TYPICAL SECTIONS

PHASE 1 - KAUMUALII HIGHWAY
LIHUE MILL BRIDGE TO RICE STREET

PHASE 3 - REHABILITATION OF LIHUE MILL
BRIDGE AND MAKAI WIDENING

"AS-BUILT"

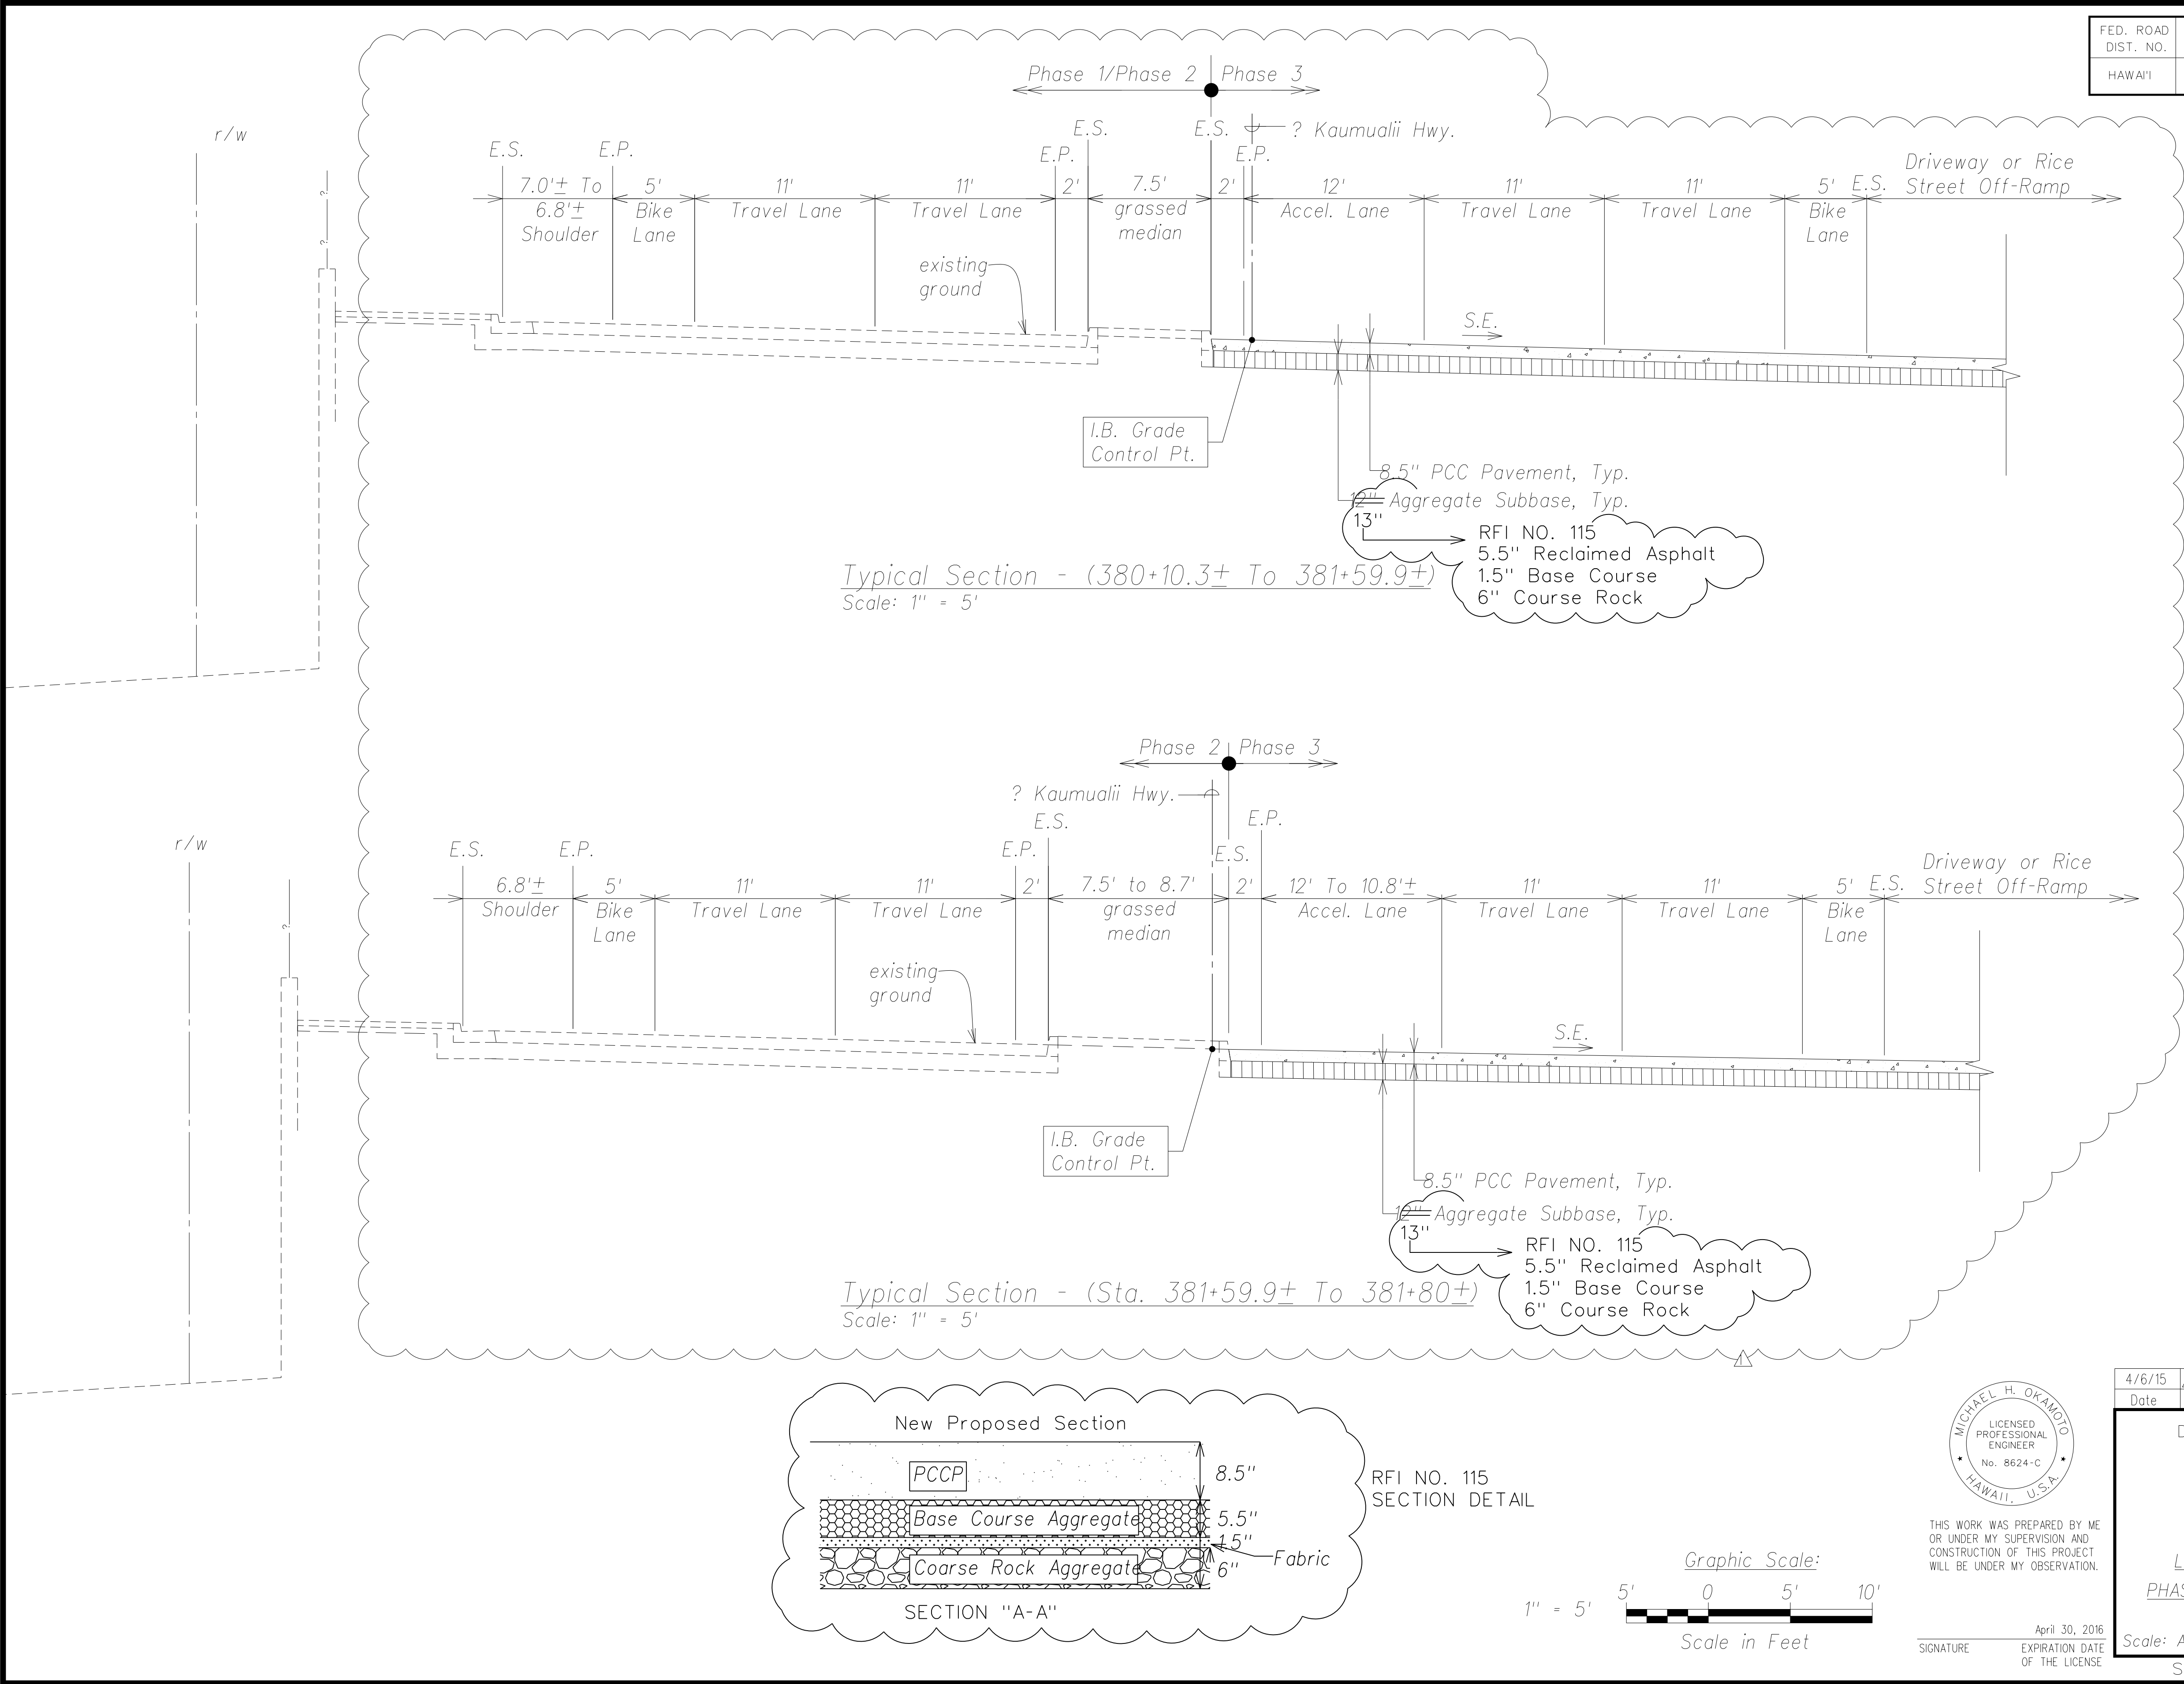
4/6/15	Revise for additional PCC pavement and work
Date	Revision
STATE OF HAWAII DEPARTMENT OF TRANSPORTATION HIGHWAYS DIVISION	
TYPICAL SECTIONS	
PHASE 1 - KAUMUALII HIGHWAY LIHUE MILL BRIDGE TO RICE STREET	
PHASE 3 - REHABILITATION OF LIHUE MILL BRIDGE AND MAKAI WIDENING	
Scale: As Shown	Date: May 2, 2014
SHEET No. C-20 OF 82 SHEETS

RFI NO. 115
SECTION DETAIL

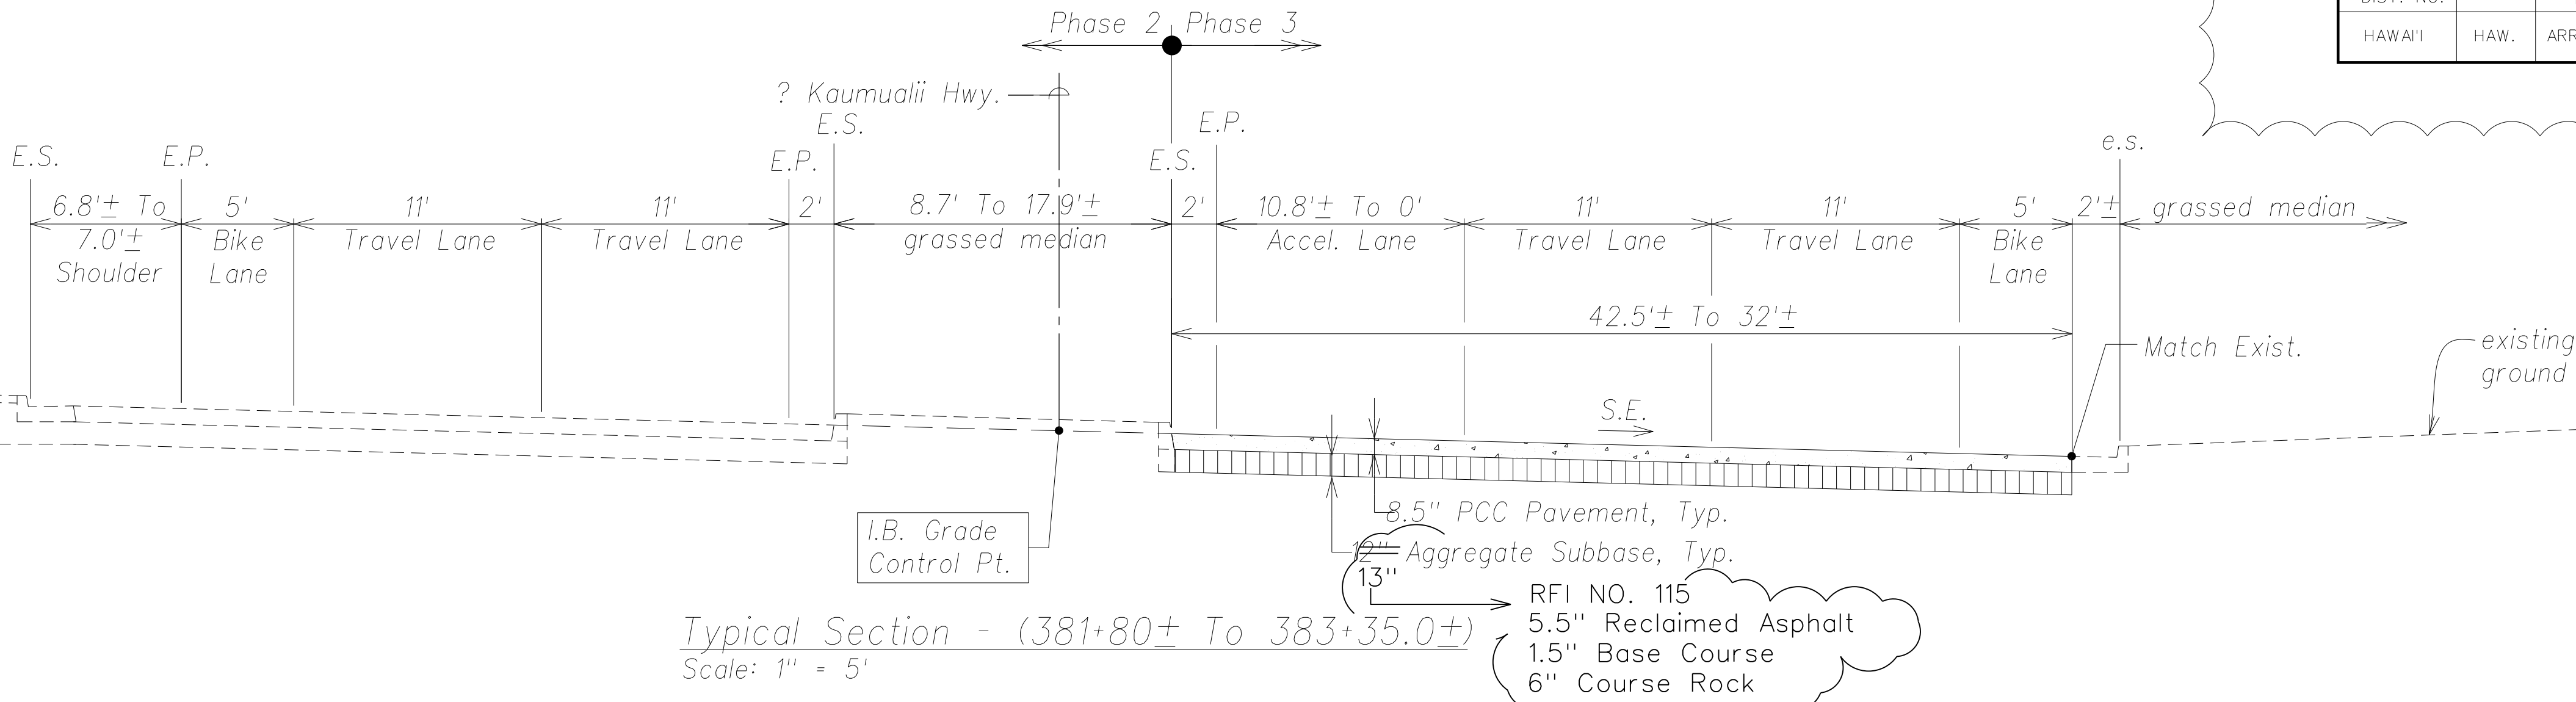
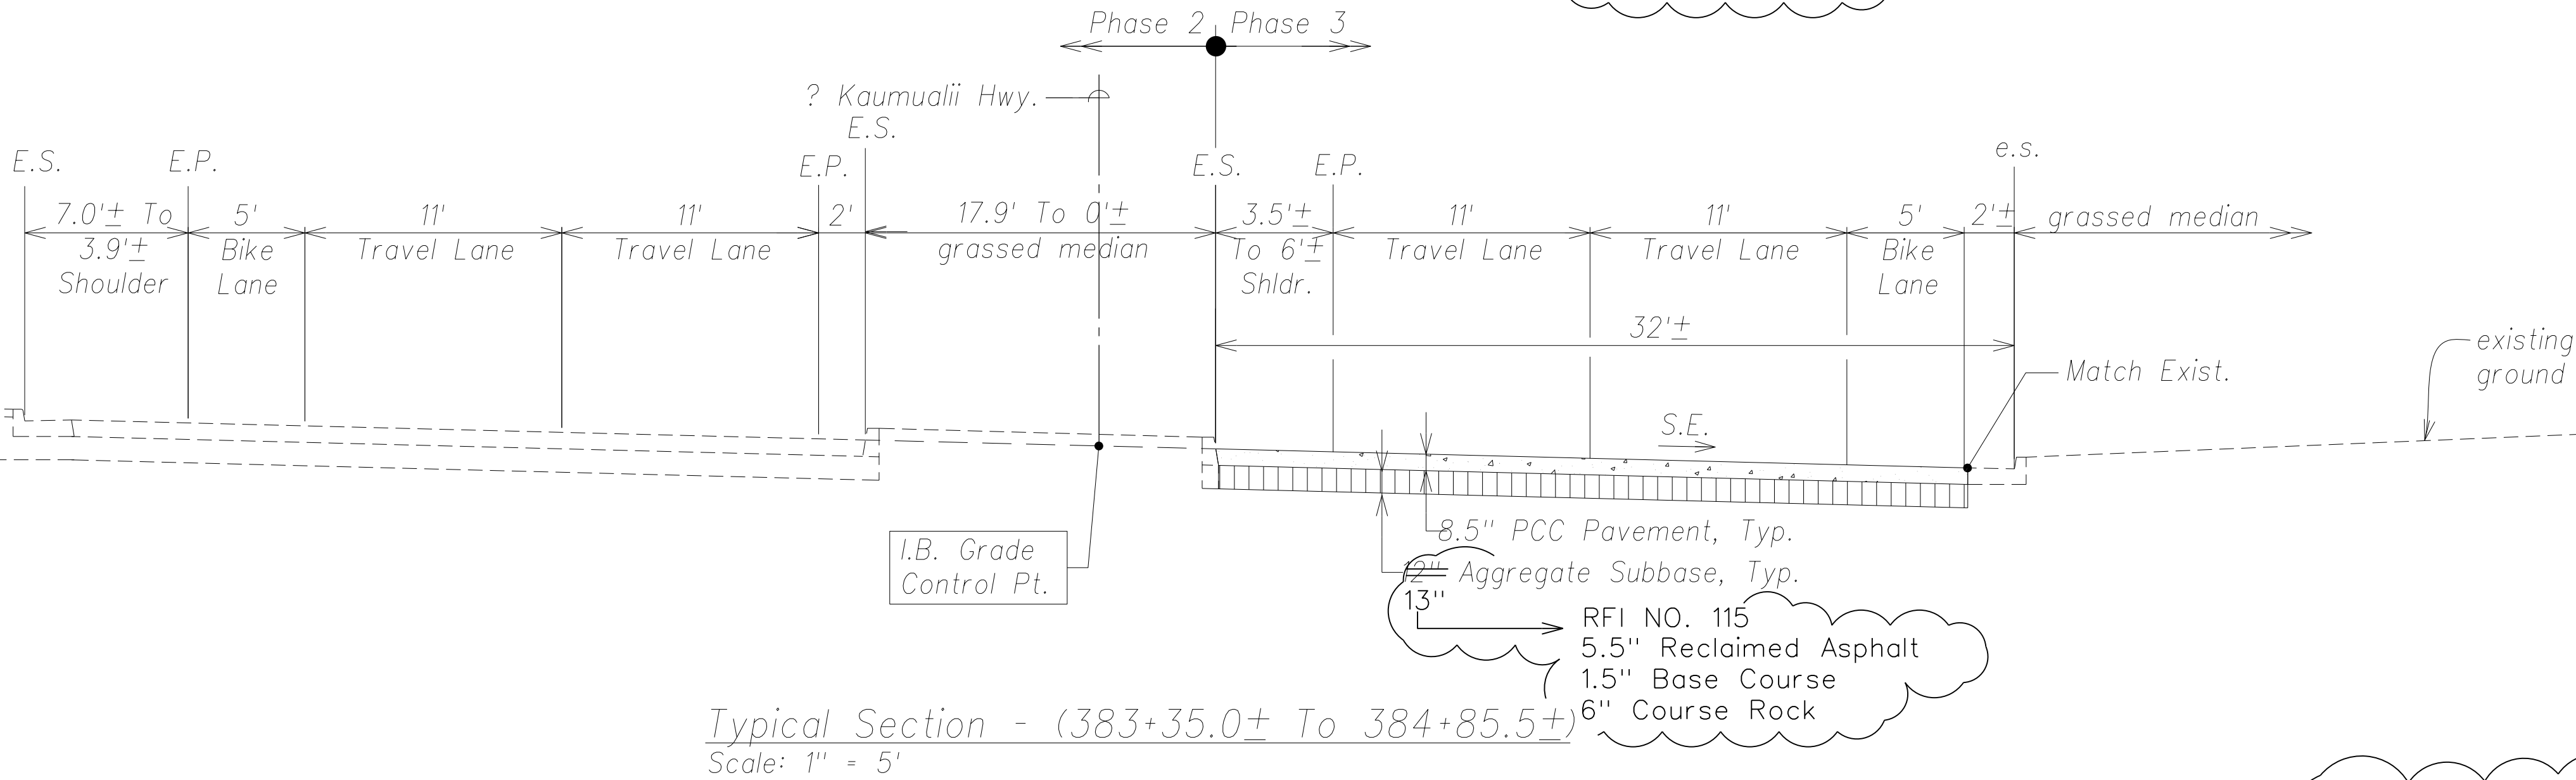
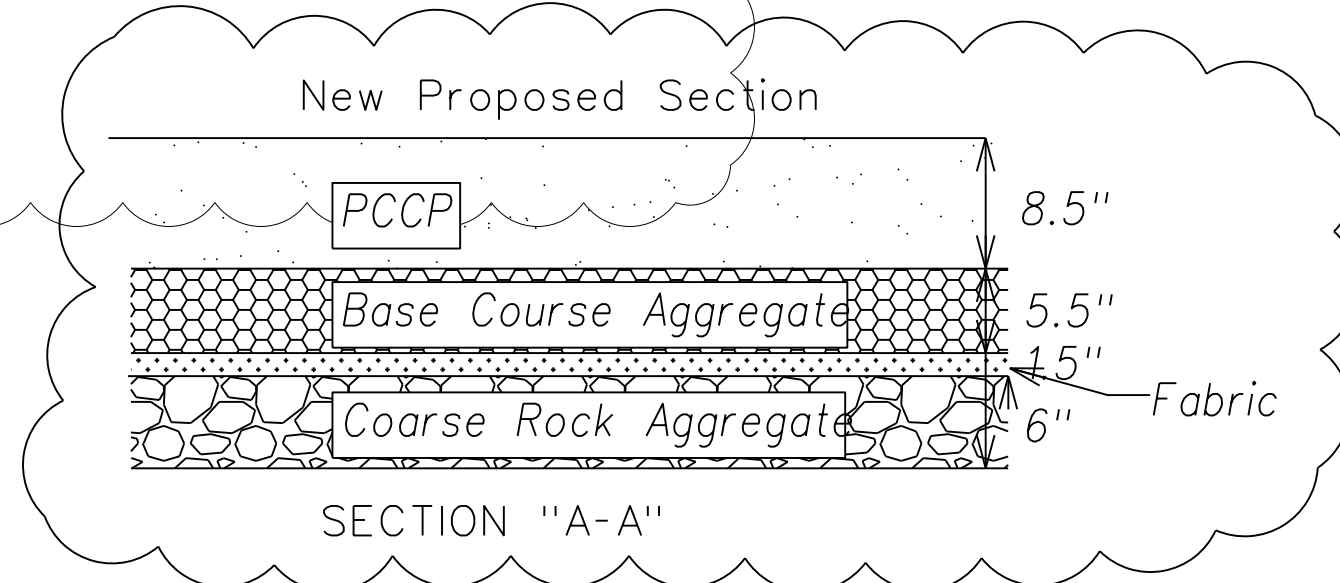
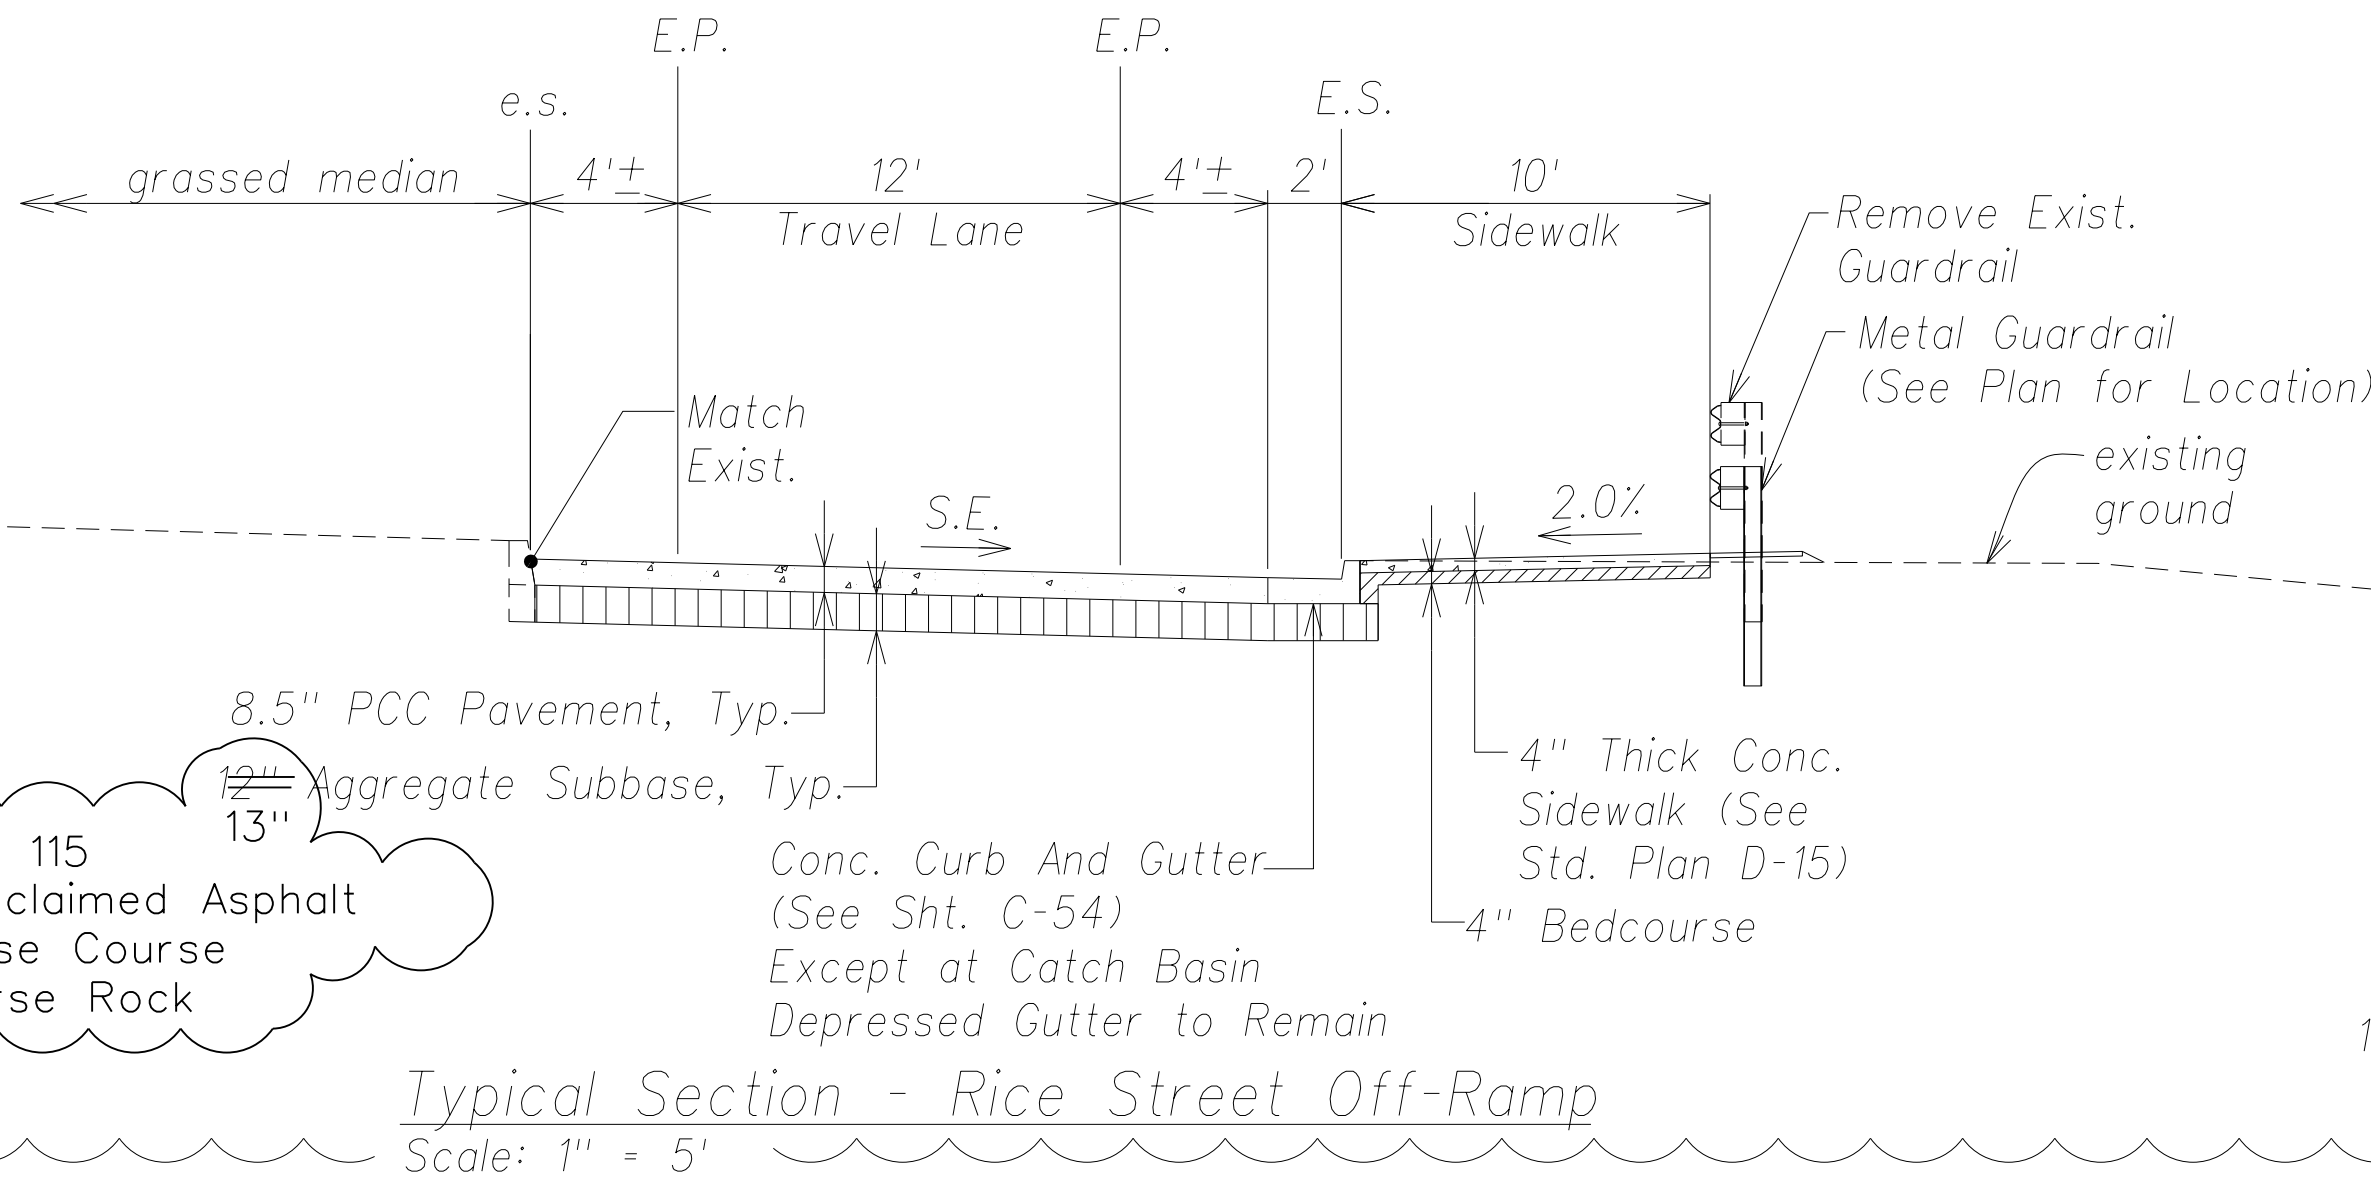
4/6/15	Revise for additional PCC pavement and sidewalk work
Date	Revision
STATE OF HAWAII DEPARTMENT OF TRANSPORTATION HIGHWAYS DIVISION	
TYPICAL SECTIONS	
PHASE 1 - KAUMUALII HIGHWAY LIHUE MILL BRIDGE TO RICE STREET	
PHASE 3 - REHABILITATION OF LIHUE MILL BRIDGE AND MAKAI WIDENING	
Scale: As Shown	Date: May 2, 2014
SHEET No. C-21 OF 82 SHEETS
